COVER SHEET CIVIL PLANS FORTRESS - PUYALLUP

Job Number 22085 Sheet C1 of 34

No.	Date	By	Chd.	Appr.	Revision
2	03/05/24	DL	DL	JSG	RESPONSE TO CITY COMMENTS, DATED FEBRUARY 06, 2024
	02/27/24	DL	DL	JSG	BID SET
1	12/06/23	DL	DL	JSG	RESPONSE TO CITY COMMENTS, DATED 10-06-2023

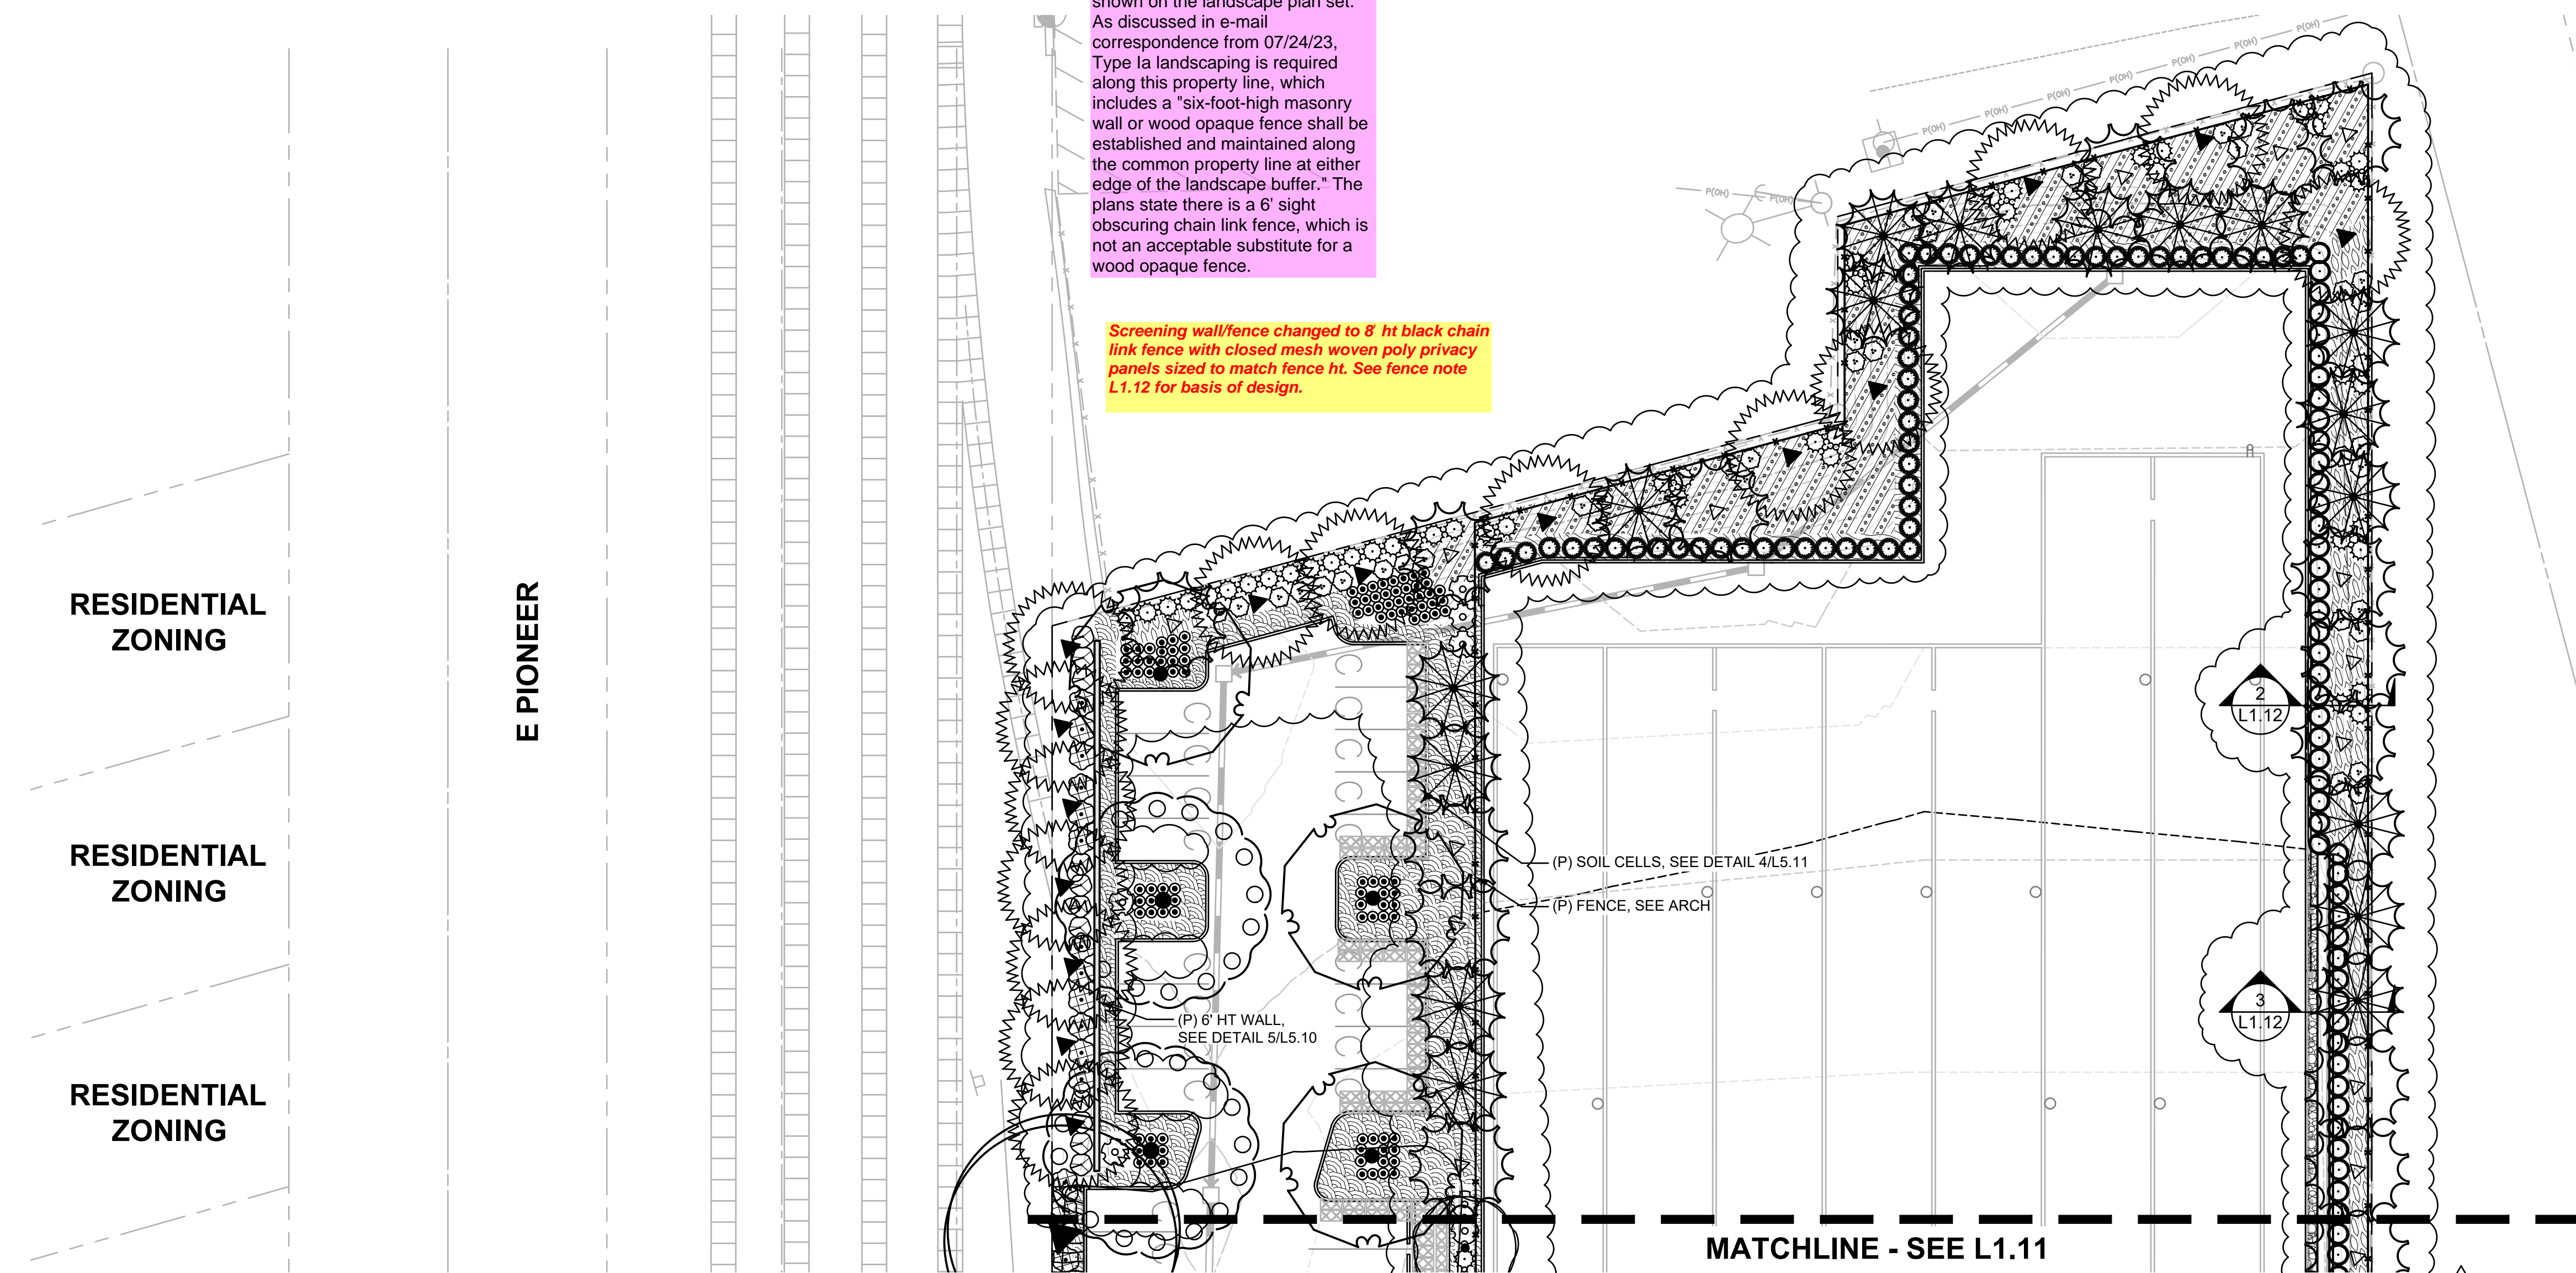
Please provide details for the fence shown on the landscape plan set. As discussed in e-mail correspondence from 07/24/23, Type 1a landscaping is required along this property line, which includes a "six-foot-high masonry wall or wood opaque fence shall be established and maintained along the common property line at either edge of the landscape buffer." The plans state there is a 6' sight obscuring chain link fence, which is not an acceptable substitute for a wood opaque fence.

Screening wall/fence changed to 8 ht black chain link fence with closed mesh woven poly privacy panels sized to match fence ht. See fence note L1.12 for basis of design.
